UNITED STATES PATENT AND TRADEMARK OFFICE

Office Action Summary

10/632,561

DETAILED ACTION

FIG. 2

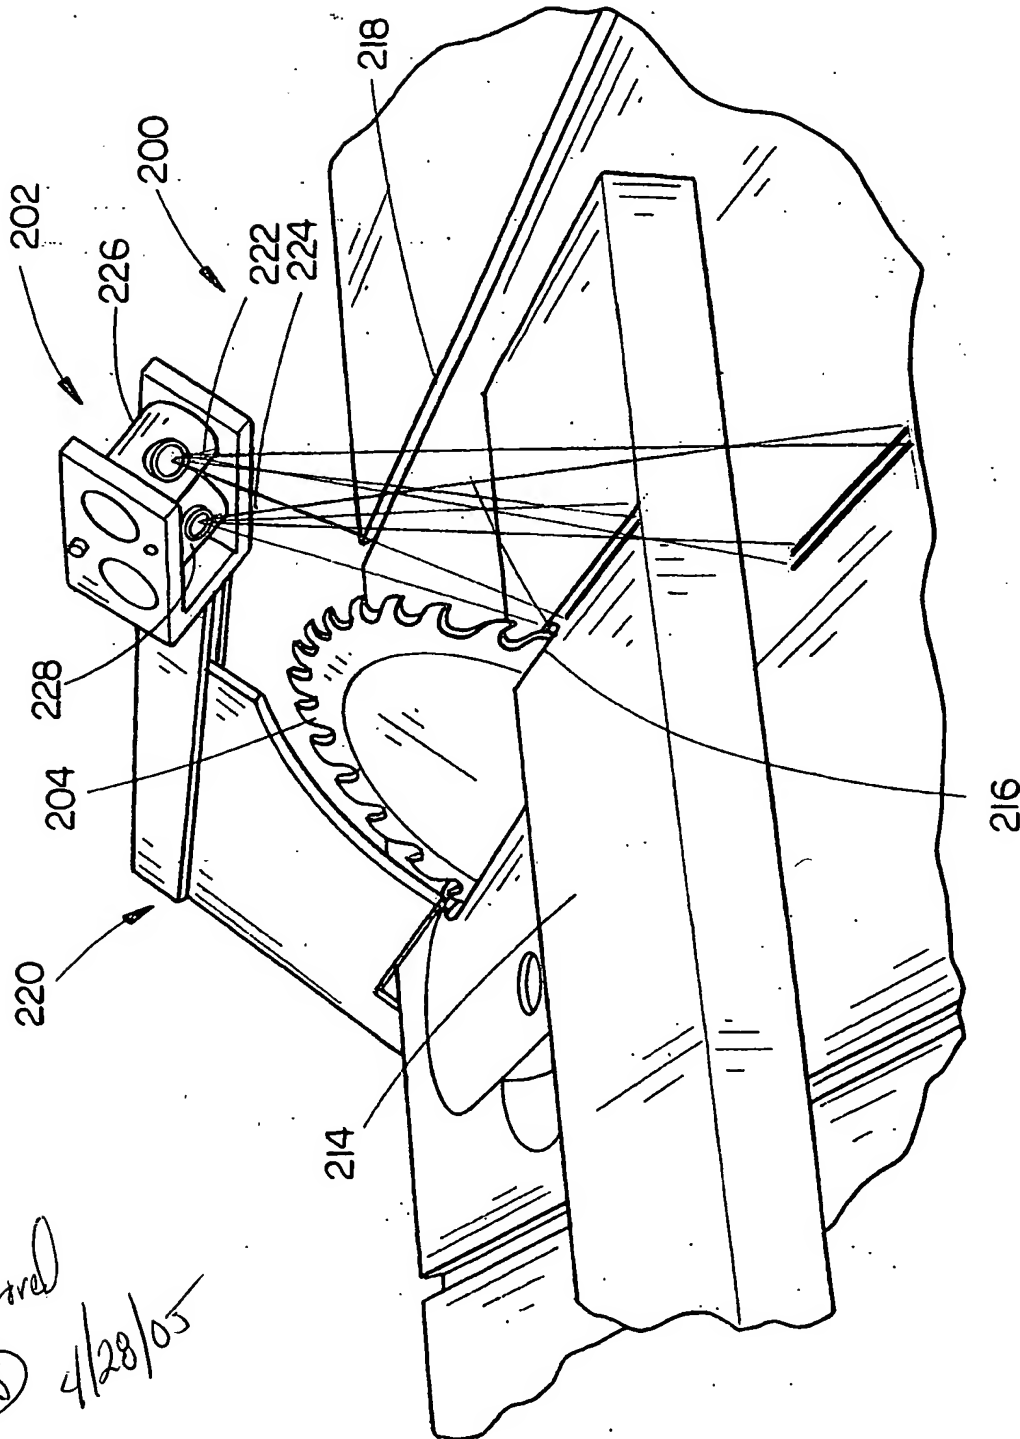
3. The proposed drawing corrections for Figures 2 and 5 filed on December 12, 2003 have been **approved**. The replacement drawings are **acceptable**.

A description has not been provided for numerals 226 and 228 shown in Figure 2.

Approved
(5) 4/28/05

FIG. 5

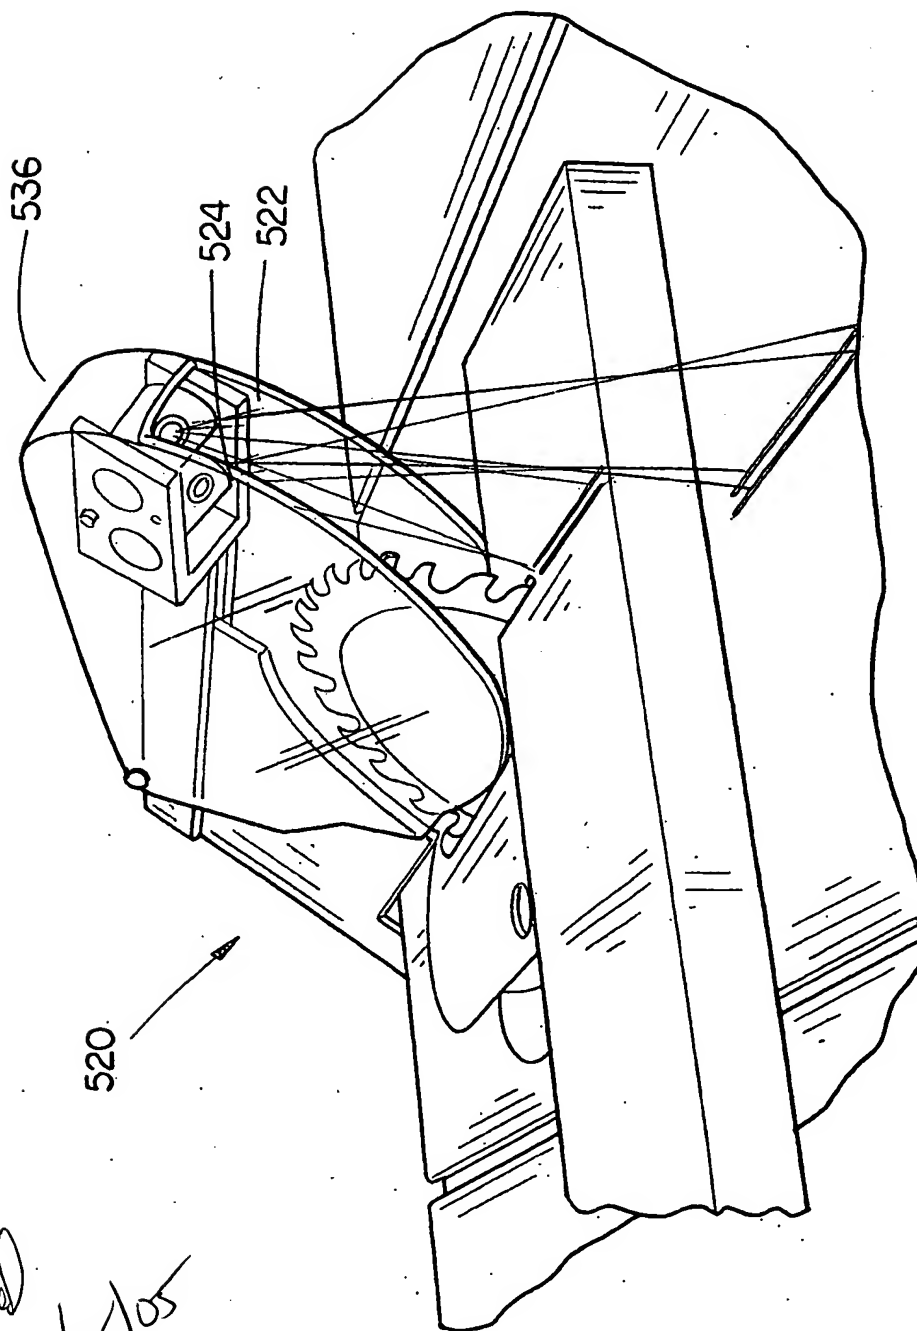
A description has not been provided for numerals 522 and 524 shown in Figure 5.

Approved
CS 4/25/05
